**RUSSELL VALE COLLIERY
REVISED UNDERGROUND
EXPANSION PROJECT**

Submissions Report – Part A

Prepared by
Umwelt (Australia) Pty Limited
on behalf of
Wollongong Coal Limited

Project Director: **Barbara Crossley**
Project Manager: **Gabrielle Allan**
Report No. **3687/R13**
Date: **November 2019**

FIGURE 5.2
 Zoning Map

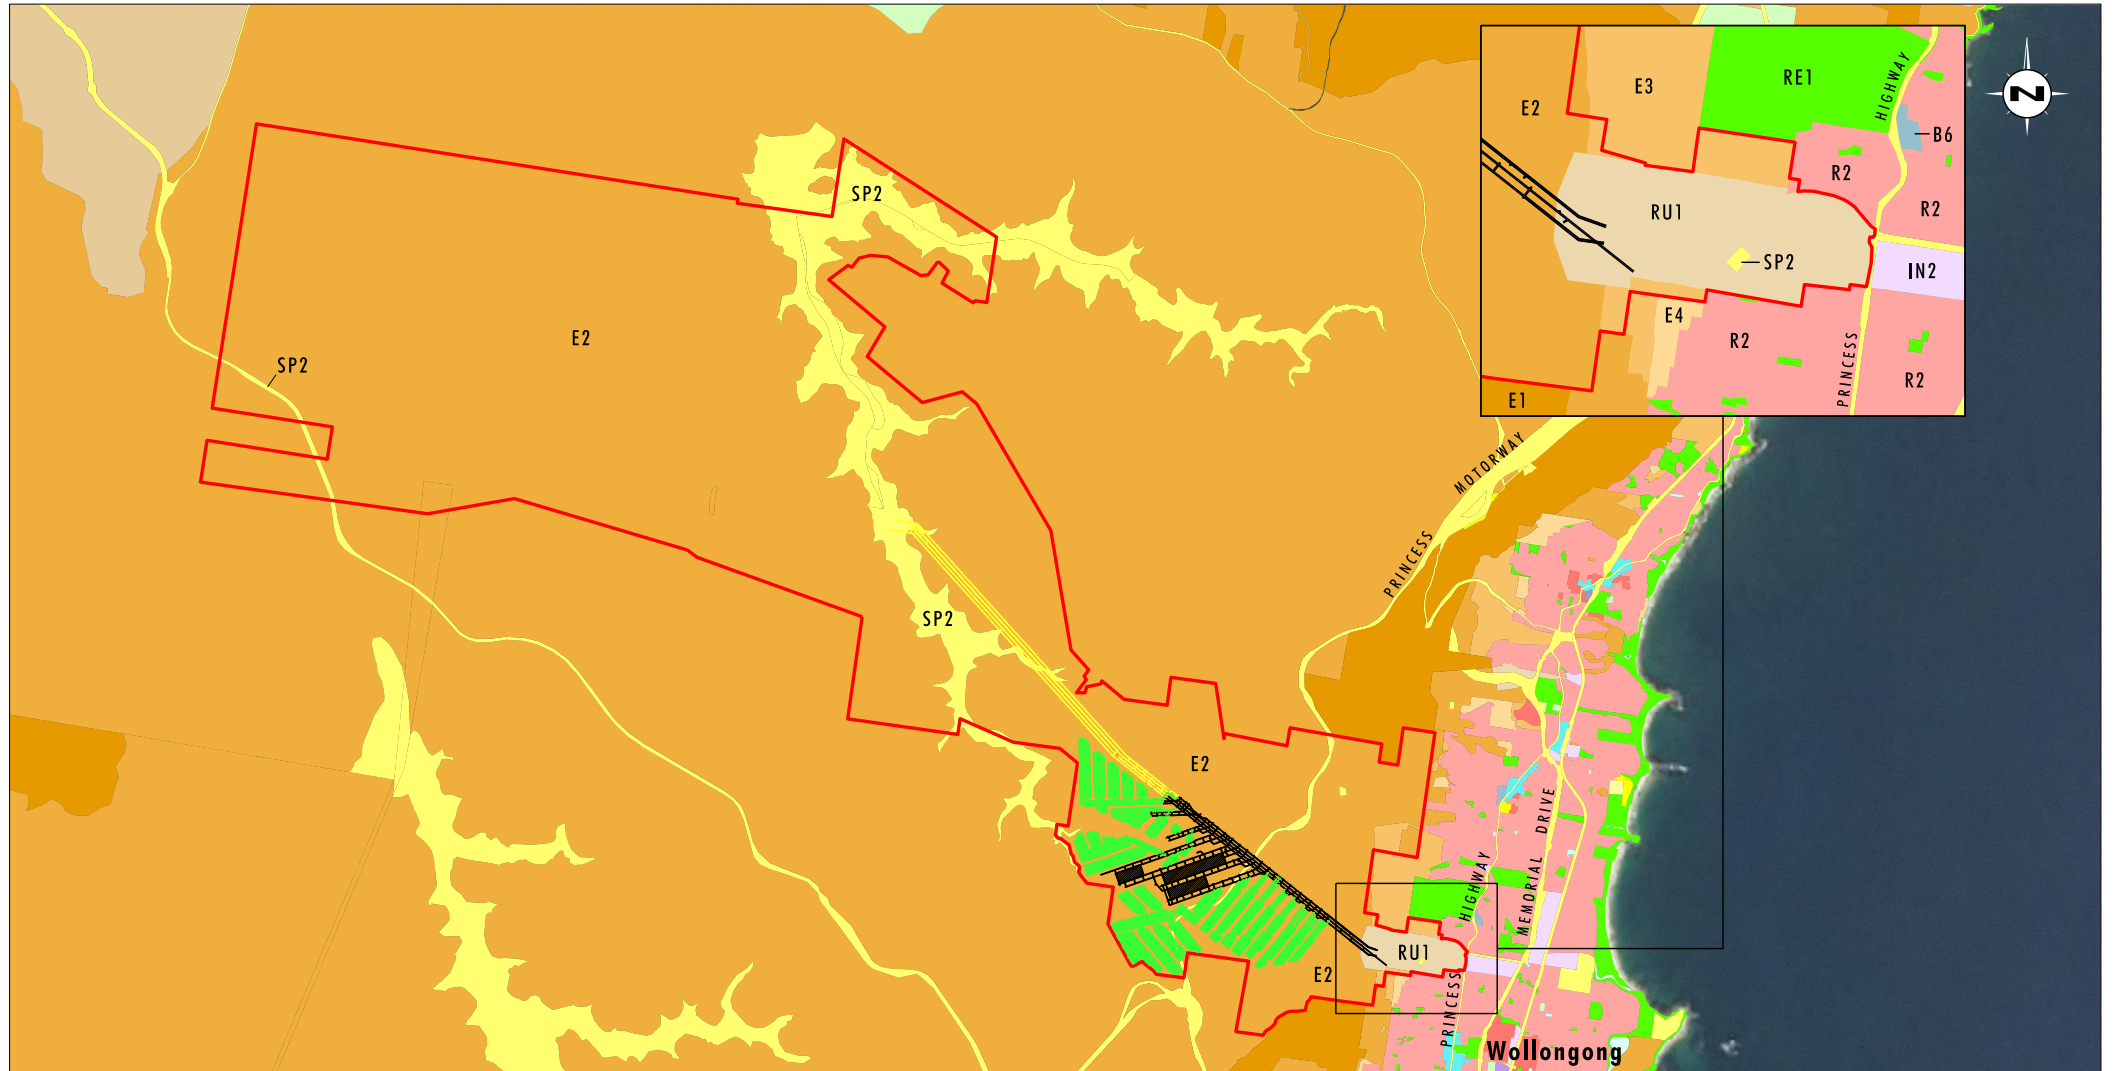
‘Relevant land zonings under each of the LEPs are shown in Figure 3.1. Zoning map Page 33 shows zoning of land around the mine site. It fails to show any residential west of Princes Hwy. It doesn’t show the WCC LEP environmental zonings along the escarpment. The map is very misleading.’

As identified in a community submission, there was an error in Figure 3.1 of the Revised Preferred Project Report resulting in the zoning being displayed incorrectly surrounding the Russell Vale Colliery Pit Top Facility. An updated zoning map is provided as **Figure 5.2**.

Despite the issue with Figure 3.1 of the Revised Preferred Project Report, all relevant assessments considered the correct zoning and land uses surrounding the Pit Top, this being primarily residential. There is no change to assessment outcomes from the Revised Preferred Project Report.

Figure 5. Existing mine workings in all three seams, plus proposed Wongawilli Seam workings
(source: SCT Report UMW4609, 2019)

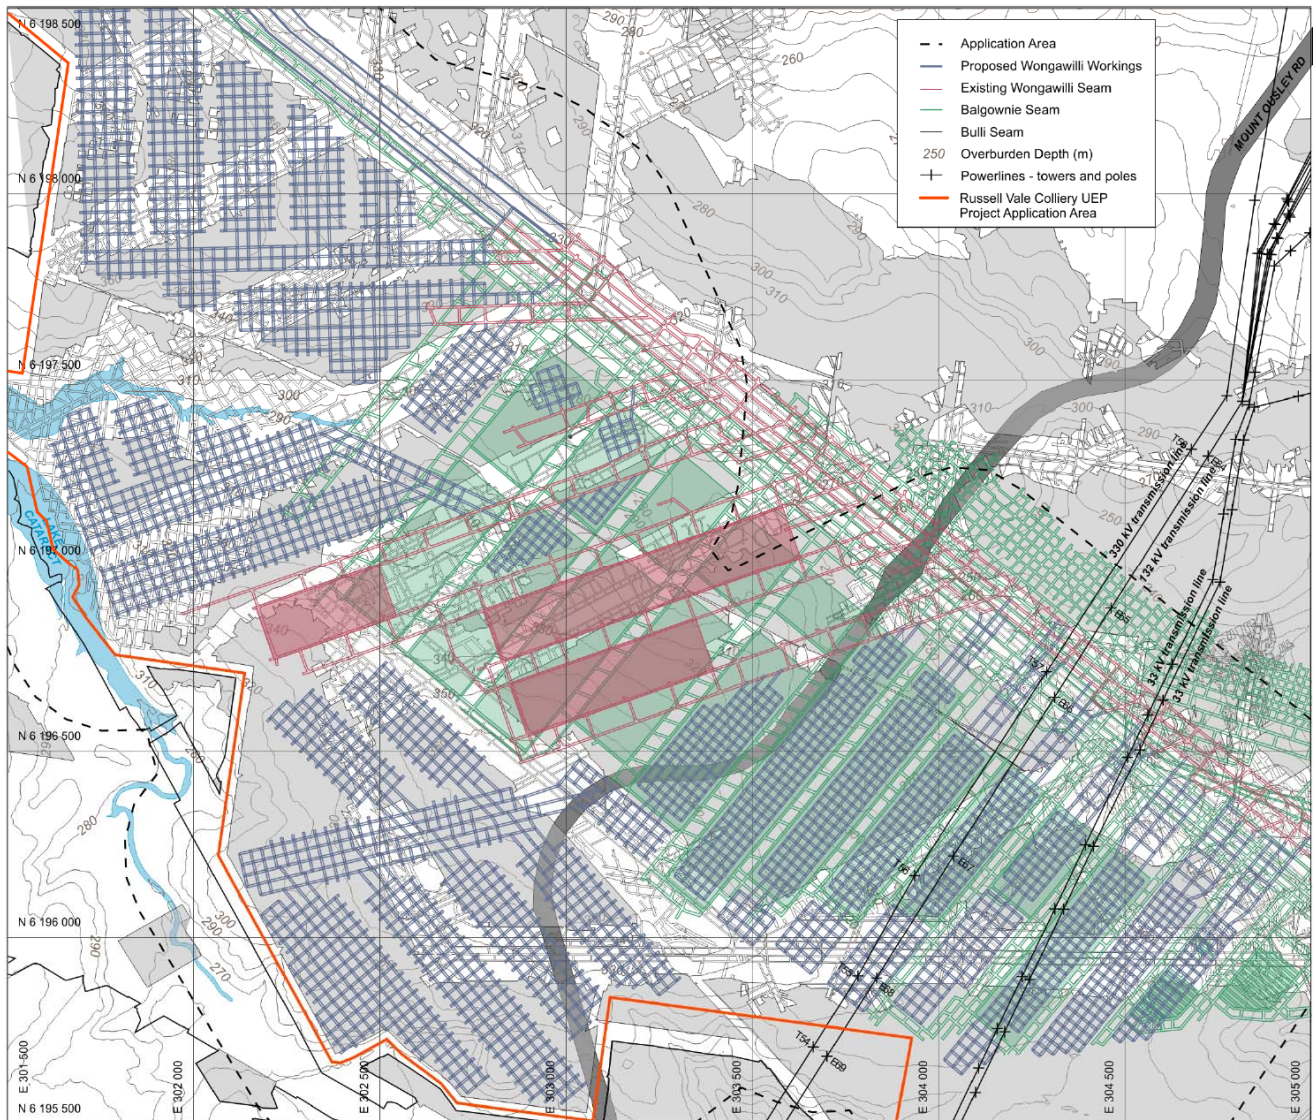
4. P18 (Previous Mining) – The plan showing all previous mining in the three seams has been reproduced as Figure 5 above. SCT has noted the design feature of aligning proposed Wongawilli Seam panels directly beneath the goaf areas of previous Balgownie Seam longwall panels. This is considered good practice for two reasons – firstly, as stated in the Report, it avoids any under-mining of the Balgownie chain pillars that might threaten their load-carrying capacity for the overlying overburden. Secondly, it provides a degree of protection for the loading applied to the pillars in the proposed new Wongawilli Seam panels. This is good practice, although there is a possibility that some of the pillars on the edges of the new panels may see some excess load due to the expanding footprint of load beneath the overlying chain pillars. This is likely to only result in localised issues, if any, rather than any serious regional instability.

Figure 7. Copy of SCT Figure 15 showing area of potentially unstable Bulli Seam pillars
(source: SCT Report UMW4609, 2019)

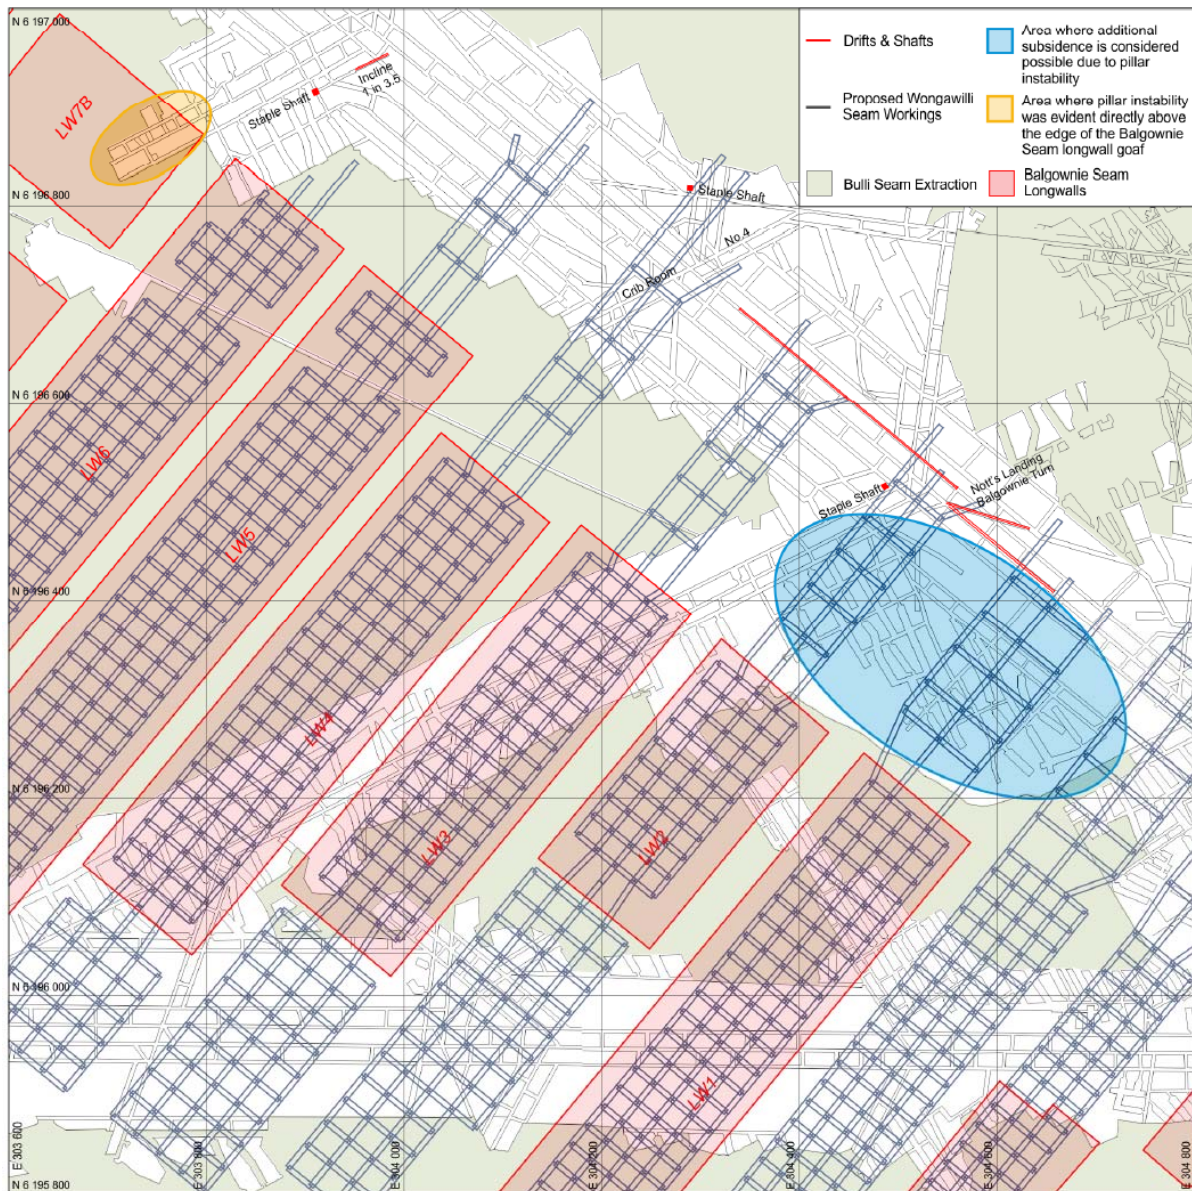
It is not intended to provide a review of the Appendices which cover previous work done in reviewing mining and subsidence impacts associated with previous mining activity. It is noted, however, that Figure 15 in the Appendices shows an area of potentially unstable small pillars in the Bulli Seam. It is unclear, though likely, that this is the area of pillars referred to on multiple occasions by SCT in the Report. A copy of Figure 15 is reproduced below, for information, as Figure 7.

Figure 13: Plan showing areas of existing and potential pillar instability in overlaying Bulli Seam.

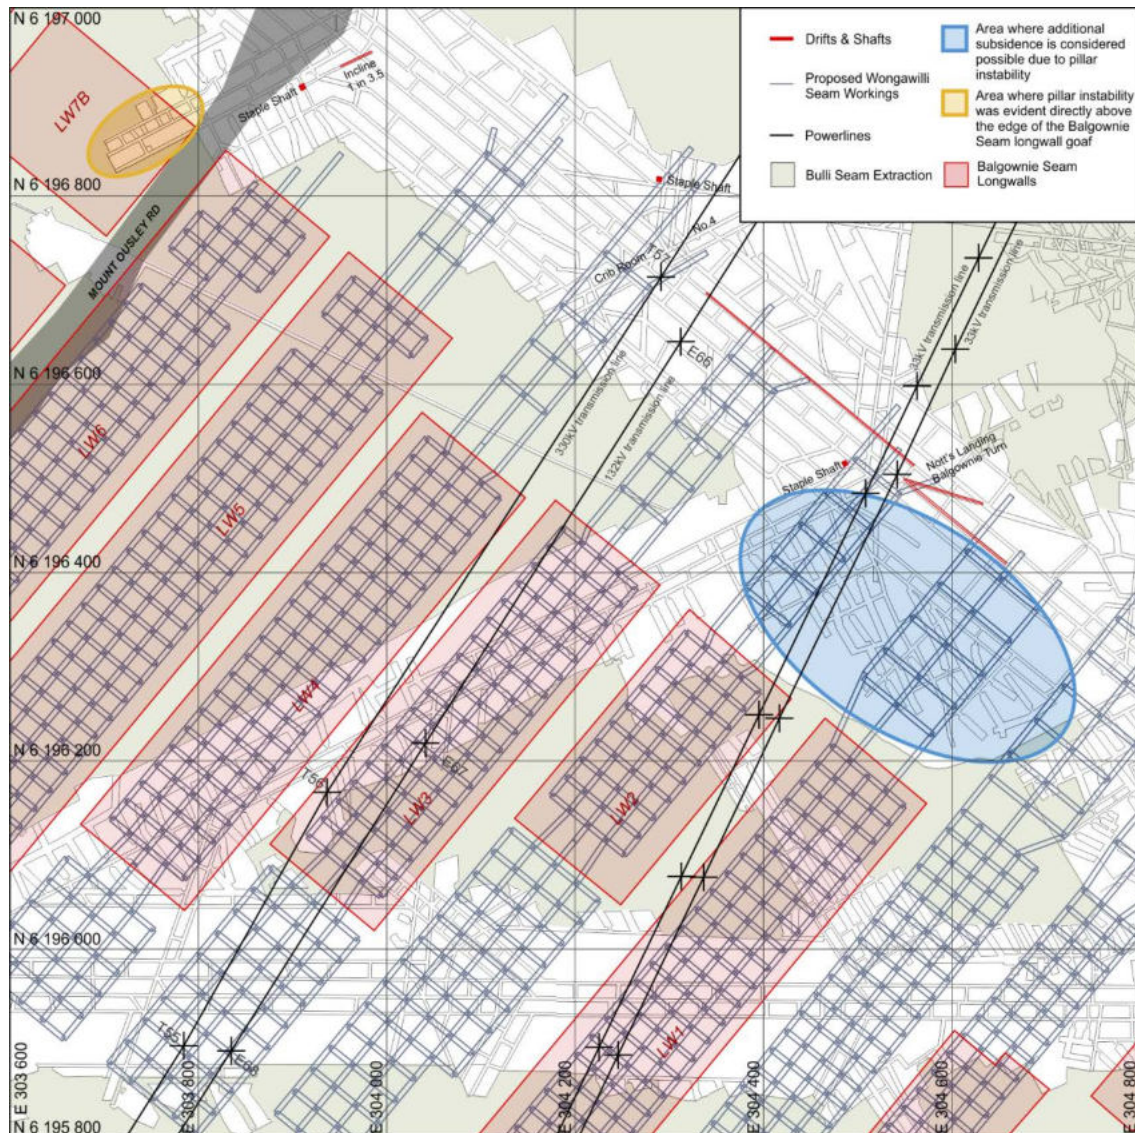
- Section 3.6, comment 5 – A copy of the previous Figure 15 from the Appendices has now been brought forward into the main report as Figure 13, to indicate one such location of marginally

- A copy of the previous Figure 15 from the Appendices has now been brought forward into the main report as Figure 13, to indicate one such location of marginally stable Bulli Seam pillars. Furthermore, a discussion is provided in relation to managing the risk of potential instability of these pillars and the possible impact on surface power line structures.
